# Belvac Production Machinery Technical Bulletin

ISSUE 2, VOLUME 10, JANUARY 2007

## 595 Light Tester Upgrade

Infeed Side  
'CIP'

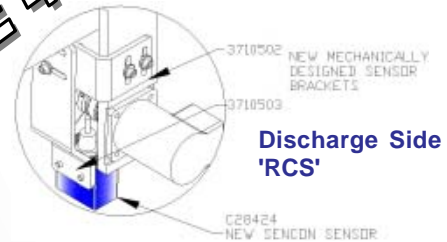
A step-by-step prompt for sensor calibration will be displayed on the Sencon two-line display and will guide the technician through the recalibration process. New sensors [C28424] have been integrated into the system and will replace existing sensors. Their rugged construction offer a wider field of view and deeper sensing range, allowing their location to be inside the can path and eliminate interference during high-speed operation. New brackets have also been designed to reduce installation time.
